Subject: MHI's Amended Response to US-APWR DCD RAI No.399-2992 Revision 0 (SRP 16)

MHI's Amended Response to US-APWR DCD
RAI No.399-2992 Revision 0
(SRP 16)

RAI NO.:	**NO. 399-2992 REVISION 0**
SRP SECTION:	**16 - TECHNICAL SPECIFICATIONS**
APPLICATION SECTION:	**16**
DATE OF RAI ISSUE:	**6/18/2009**

QUESTION NO.: 16-298

Figure 16.298-1 Pressurizer Water Volume vs. Time
Loss of Non-Emergency AC Power (DCD Subsection 15.2.6)

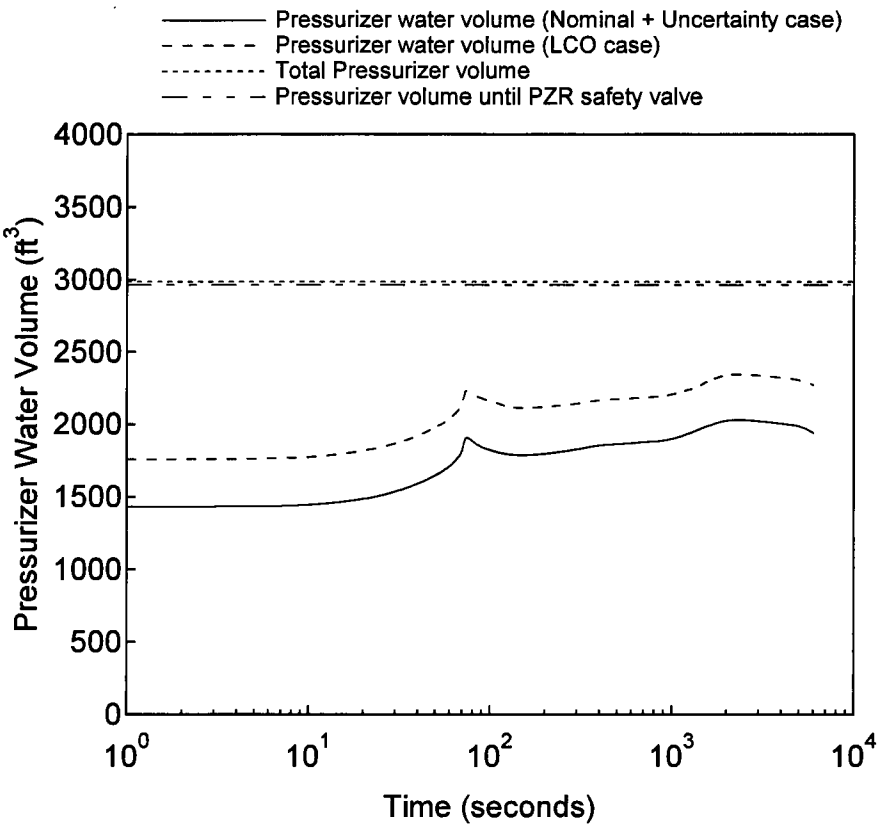
Provide justification for the selected pressurizer water level limit of 92% specified in LCO 3.4.9.a and SR 3.4.9.1. Revise LCO 3.4.9.a, SR 3.4.9.1 and the associated TS bases, as appropriate.

In the APWR DCD Section 15.2, the initial conditions of the pressurizer water volume assumed in all heatup transients are below 1500 cu-ft. (see Figures 15.2.1-4, 15.2.7.4 and 15.2.8-3) which is less than 50% of the total pressurizer water volume (3000 cu-ft). A heatup transient or accident initiated at 92% pressurizer water level constitutes an unanalyzed event which could lead to a water solid pressurizer and liquid release through the pressurizer safety valves.

MHI has reanalyzed the DCD 15.2.6 and 15.2.7 events to include an additional pressurizer overfill case that uses the revised TS LCO 3.4.9 value of 60% as the initial pressurizer water level. The results for the two events are shown below in Figure 16-298.1 and Figure 16-298.2, respectively. In addition, the pressurizer volume figures include a line indicating the volume associated with the physical location of the safety valves. As indicated by the figures, the location of the valves is very near the top of the pressurizer and therefore the line lies just below the maximum pressurizer volume line. The 60% LCO value provides significant margin to either of these lines such that the small difference between the location of the valves and the top of the pressurizer is negligible. This confirms that the possibility of water or two-phase relief from these valves is precluded for these limiting Chapter 15 AOOs and that pressurizer overfill does not occur. The DCD sections for these two events will be revised to include the case starting from the TS LCO 3.4.9 as discussed in the "Impact on DCD" section below.

The loss of non-emergency AC power to the station auxiliaries (15.2.6) and loss of normal feedwater flow (15.2.7) are both revised to include an additional pressurizer overfill case using the revised LCO 3.4.9 limit as the initial condition for pressurizer water level. See Attachment 3 for the mark-up of DCD Sections 15.2.6 and 15.2.7 associated with the revised analysis results.

DCD Figures 15.5.2-1 through 15.5.2-5 will be revised as follows to reflect the analysis results consistent with the above changes.

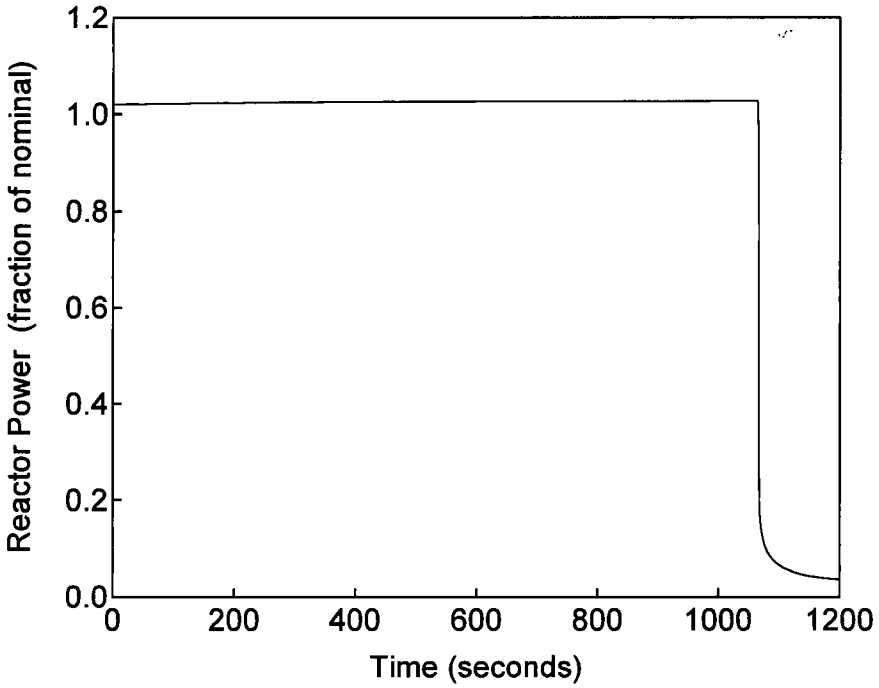
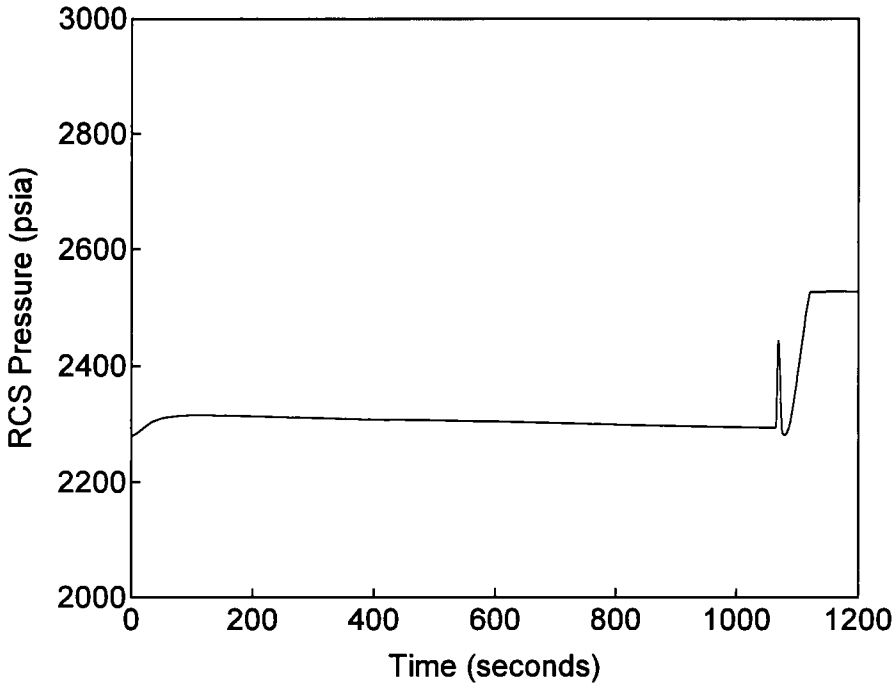
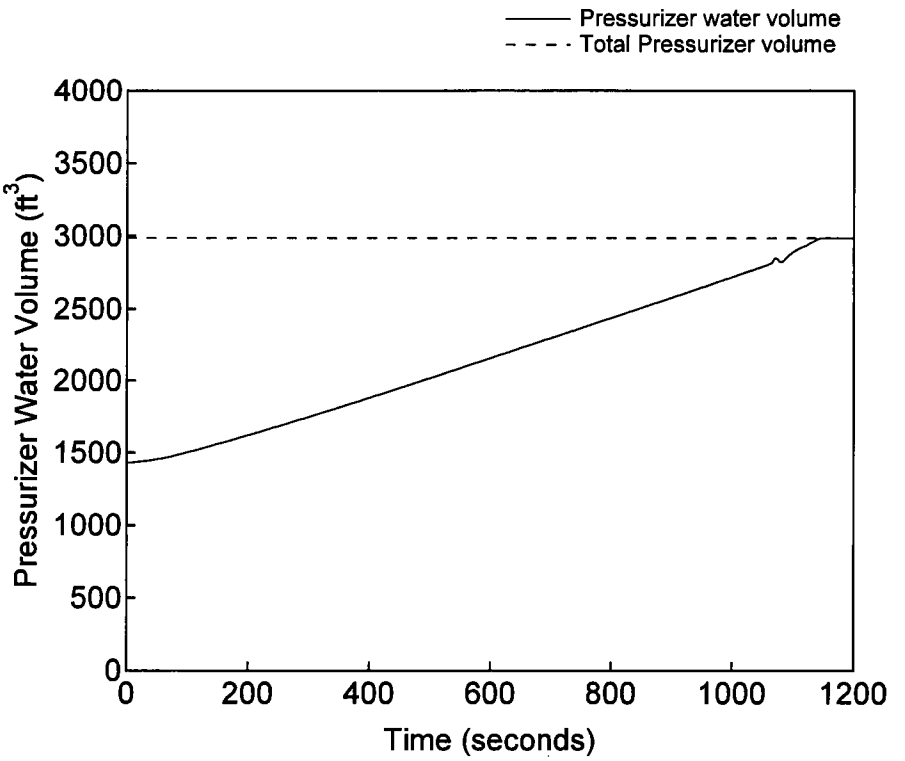
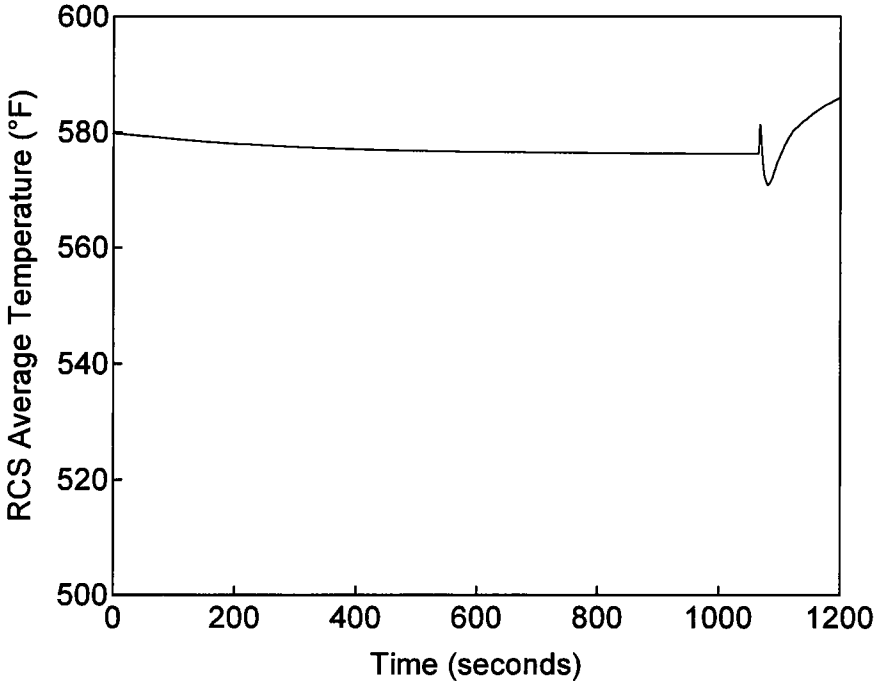
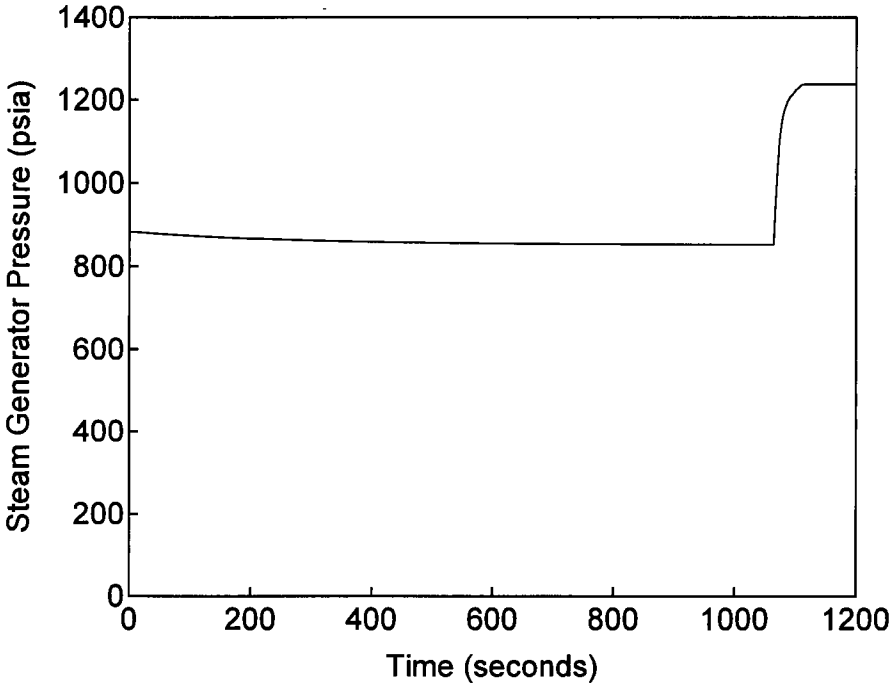
As described in this RAI response, DCD Section 15.5.2, "CVCS Malfunction that Increases Reactor Coolant Inventory", is revised to credit automatic isolation of CVCS with the occurrence of the high pressurizer water level signal for event termination. As a result of this change, DCD Table 7.5-5 and Section 15.0.0.6 are also revised in order to maintain consistency between the various places within the DCD that discuss manual operator actions. See Attachment 1 for the mark-ups of DCD Table 7.5-5, DCD Section 15.0.0.6, and DCD Section 15.5.2 corresponding to this change.

Figures 15.5.2-1 through 15.5.2-5 are plots of the transient response of system parameters for the Barrier Performance Evaluation case.

In the evaluated case, the full-open failure of the charging flow control valve with one pump running leads to an addition of mass to the RCS resulting in an increase in the pressurizer water volume. Table 15.5.2-1 shows that the high pressurizer water level alarm occurs 404 seconds after the CVCS malfunction occurs. Table 15.5.2-1 shows that the reactor trips at 1062 seconds, as indicated by the distinctive drop in reactor power and RCS temperature at this time in Figures 15.5.2-1 and 15.5.2-4. The RCPs coast down at the same time due to the assumed LOOP. The CVCS charging pump continues to inject water until the pressurizer fills, which occurs at ~~1176~~ 1146 seconds per Figure 15.5.2-3. Thus, there are ~~12.8~~ 12.3 minutes available after the high pressurizer level alarm for the operator to perform actions to end the transient before the pressurizer fills. This case demonstrates that a reasonable amount of time exists for the operators to terminate this event if operator action were necessary. However, the event is actually terminated by the automatic CVCS isolation function described in Subsection 7.3.1.5.11. After the high pressurizer water level setpoint for CVCS isolation is reached, the charging line isolation valves will close and no further increase in PZR level will occur. Therefore, this event does not result in pressurizer overfill.

Figure 15.2.6-4 **Pressurizer Water Volume versus Time**

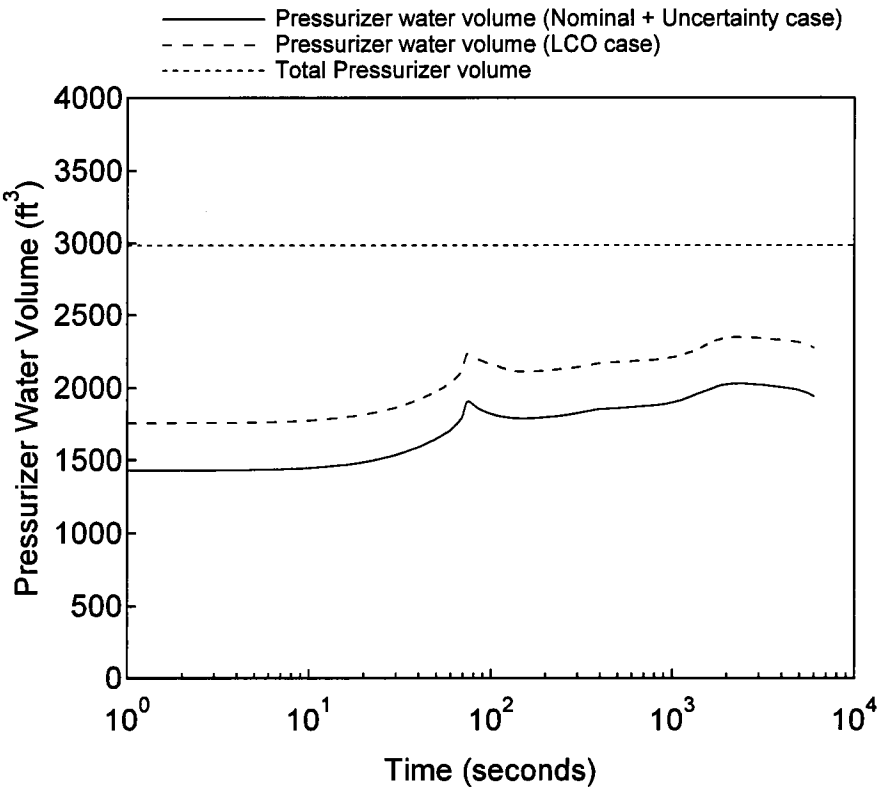
Figure 15.2.6-4 is revised to include the pressurizer water level transient for the new LCO case, in addition to the existing nominal plus uncertainty level case.

> Figure 15.2.6-4 shows that the maximum pressurizer water volume remains well below the pressurizer capacity throughout the transient regardless of whether the initial pressurizer water level is at the nominal plus uncertainty or LCO water level. Therefore, ~~all pressurizer safety valve flow is steam since~~ the pressurizer does not fill with water and water relief through the pressurizer safety valves is precluded.

Figure 15.2.7-11 **Pressurizer Water Volume versus Time**

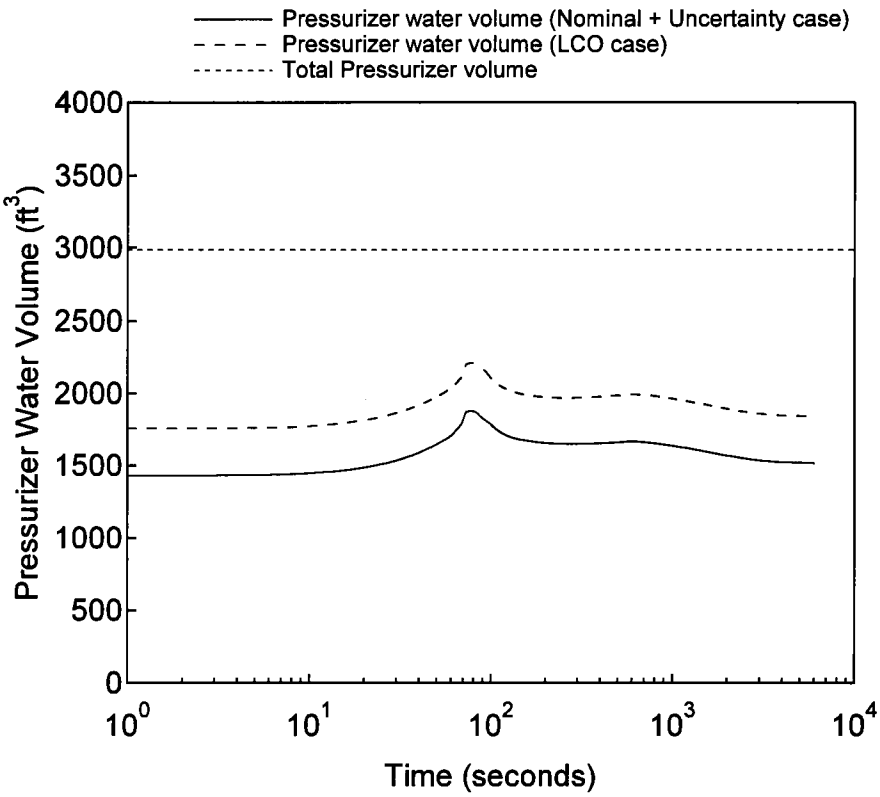
DCD Figure 15.2.7-11 is revised to include the pressurizer water level transient for the new LCO case, in addition to the existing nominal plus uncertainty level case.

> Figure 15.2.7-11 shows that under conditions that maximize pressurizer water volume, the maximum pressurizer water volume remains well below the pressurizer capacity throughout the transient regardless of whether the initial pressurizer water level is at the nominal plus uncertainty or LCO water level. Therefore, the pressurizer does not fill with water and water relief through pressurizer safety valves is precluded. EFW is sufficient to provide decay heat removal from the steam generators following reactor trip until the RHR system can be used. No other plots are provided for the peak pressurizer water volume cases since the other parameters of interest are enveloped by the base barrier performance analysis case for peak RCS pressure.
